PLANNING BOARD REPORT PORTLAND, MAINE

Residential townhouse - 6 unit condominium
133 York Street
Level III Site Plan and Subdivision
Project ID 2013-187
133 York, LLC, Applicant

Submitted to: Portland Planning Board Public Hearing Date: November 12 th , 2013	Prepared by: Jean Fraser, Planner Date: November 8 th , 2013 Planning Board Report # 50-13
---	--

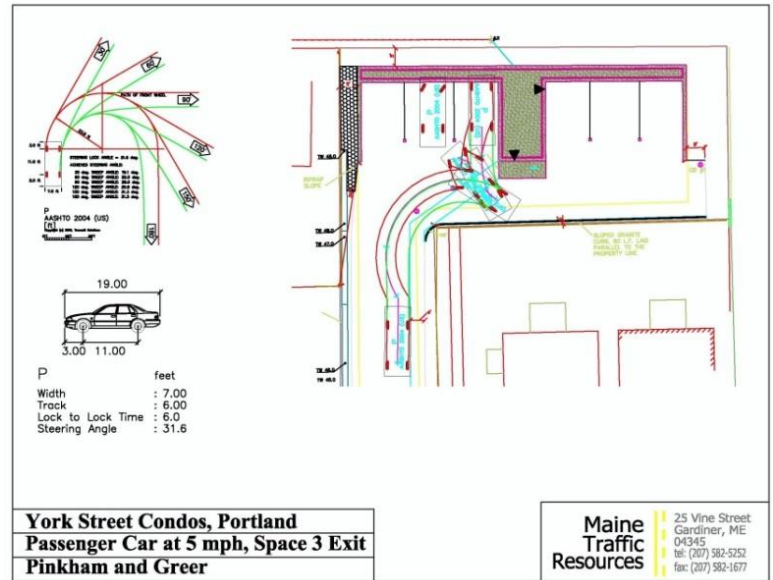
The size and placement of the building results in a narrow parking aisle leading to the 6 parking spaces located underneath the building. This potentially could cause congestion if the layout encouraged residents to back out of the drive onto York Street, which is heavily trafficked at this location near the bridge to South Portland. For this reason the Traffic Engineering Reviewer, Tom Errico, requested turning templates to illustrate the feasibility of access/maneuvering (Attachment 2). These were submitted and two of the parking spaces appeared

difficult to access (see [Attachment Y](#); an example is at right); Mr Errico wanted to confirm the adequacy of maneuvering space, as he has commented ([Attachment 14](#)):

- Access and egress movements into the garages appear difficult given the narrow pavement area. The applicant shall provide turning template graphics for a standard passenger car illustrating the ability of vehicles to adequately circulate on-site.

Status: The applicant has provided the requested turning template graphics. Given site constraints, I also requested that the applicant provide a simulated site layout in a parking area so that I could determine if vehicles could access/egress the parking garages. Based upon the field study, some garages will require multiple maneuvers (k-turns) to enter and exit the garages. The site is very constrained and the ease in which vehicles can make their intended maneuver will be a function of the design vehicle. My field simulation was based upon a Subaru station wagon and this represents a mid-size vehicle. Large Single-Unit Vehicles (SUV) will have greater difficulty.

With all that said, I do support a waiver from our technical standards for parking lot aisle width dimensions. The waiver is suggested given the unlikelihood that vehicles will back down the driveway into York Street. There is a significant distance between the garages and York Street, and thus feel that all maneuvers will occur on-site. I would note that the bicycle rack should be relocated so that it does not impede circulation. Additionally, it will be very important that snow removal/maintenance is effective so that snow does not further constrain the site.
